S/D 89-31 - Q-TECH ADDITION

Q-TECH ADDITION

FINAL PLAT

Re: S/D 89-31 - Q-TECH ADDITION

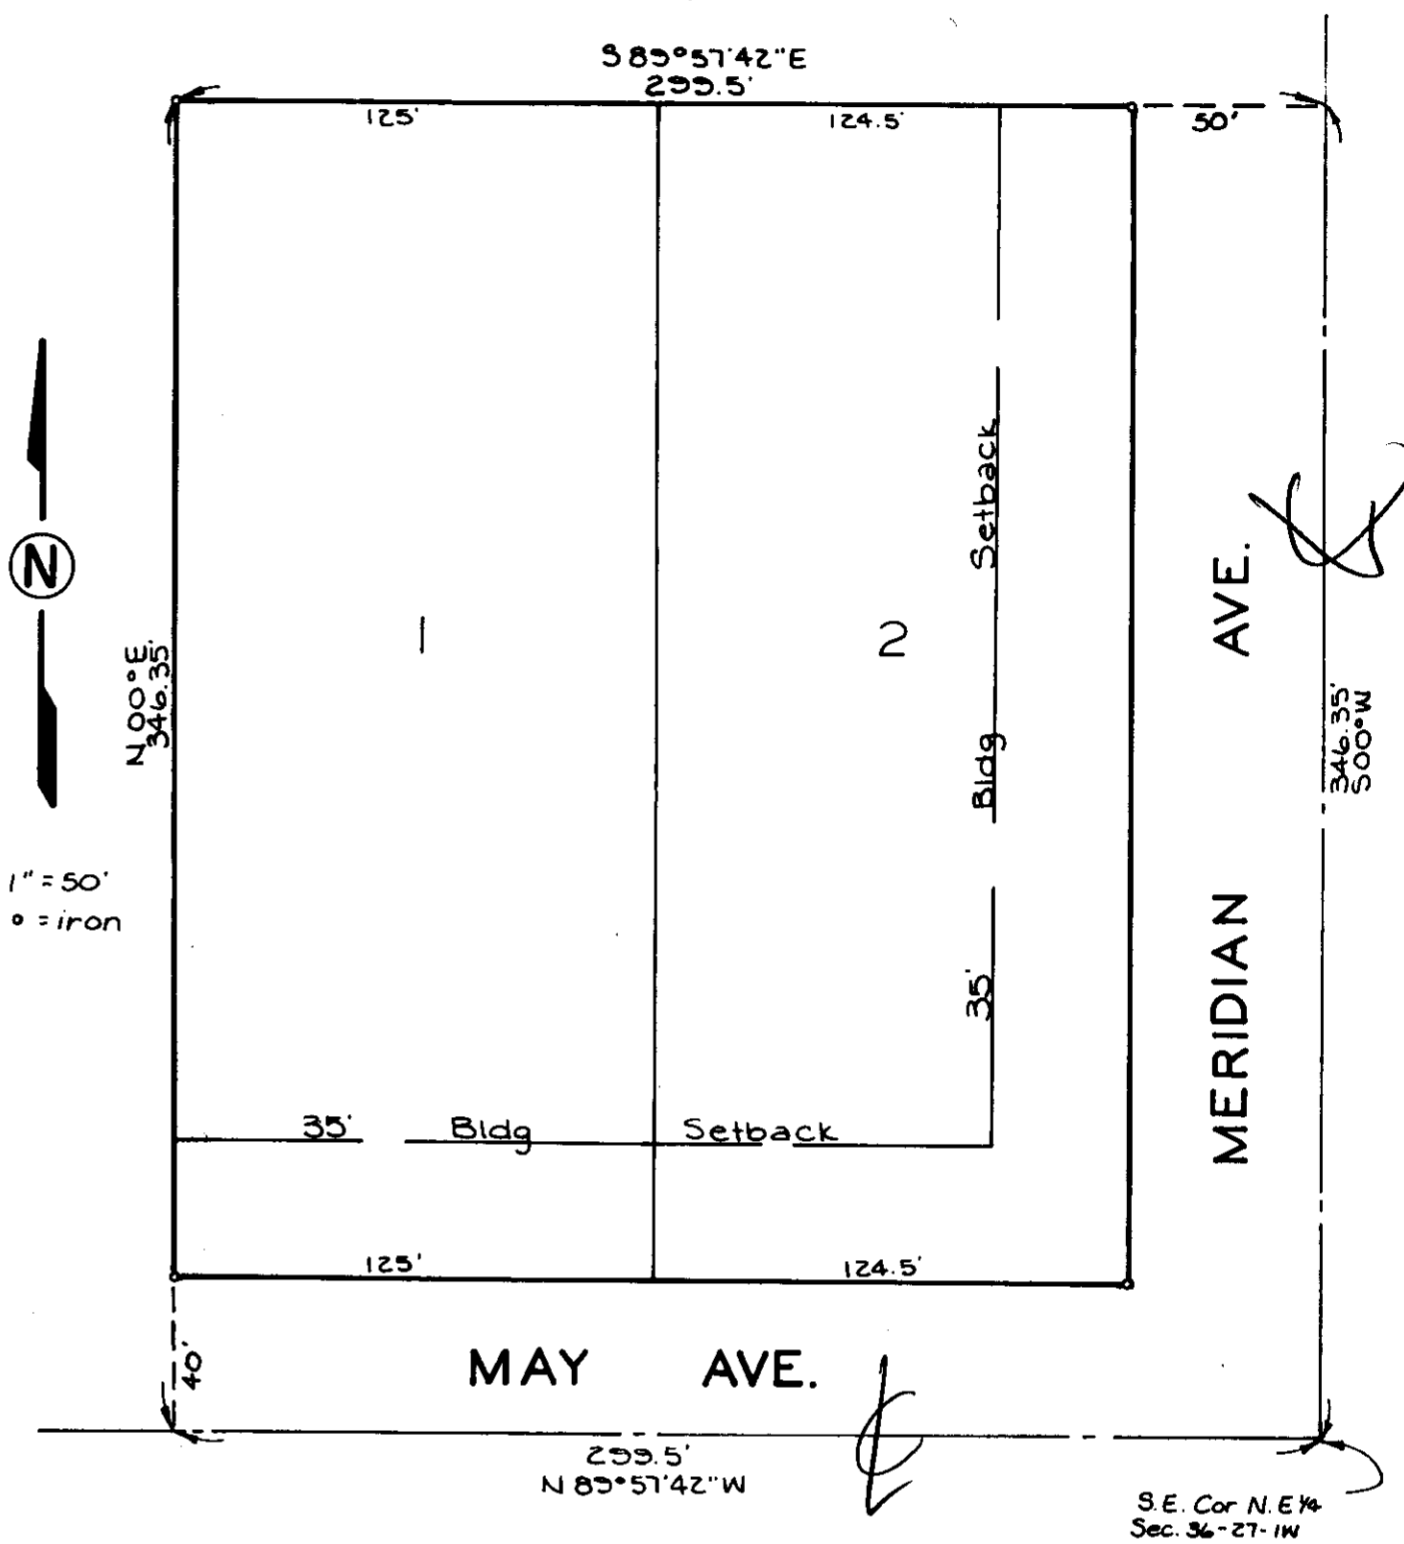
M. The representative from the City Engineer's office should be prepared to comment on the status of the applicant's drainage plan. Specifically, are any drainage guarantees required with the platting of this property?

- A. The applicant shall guarantee the extension of sanitary sewer to serve the lots being platted.
- B. The applicant shall guarantee any drainage improvements required by the platting of this property.

- D. The final plat tracing shall indicate complete access control except for one (1) opening on Meridian Avenue to and from Lot 2. The platting's text shall be amended to reflect this access control dedication.

- E. The final plat tracing shall properly reference the center line of May Ave. and Meridian Ave.
- F. The final plat tracing shall clearly dimension the north-south property lines of Lots 1 and 2 (minus street right-of-way for May Avenue).

- G. Perimeter closure computations shall be submitted with the final plat tracing. Section 5-101(c).
- H. Recording of the plat within 30 days after approval by the City Council.

- L. The representatives from the utility companies should be prepared to comment on the need for utility easements to be platted on this property.
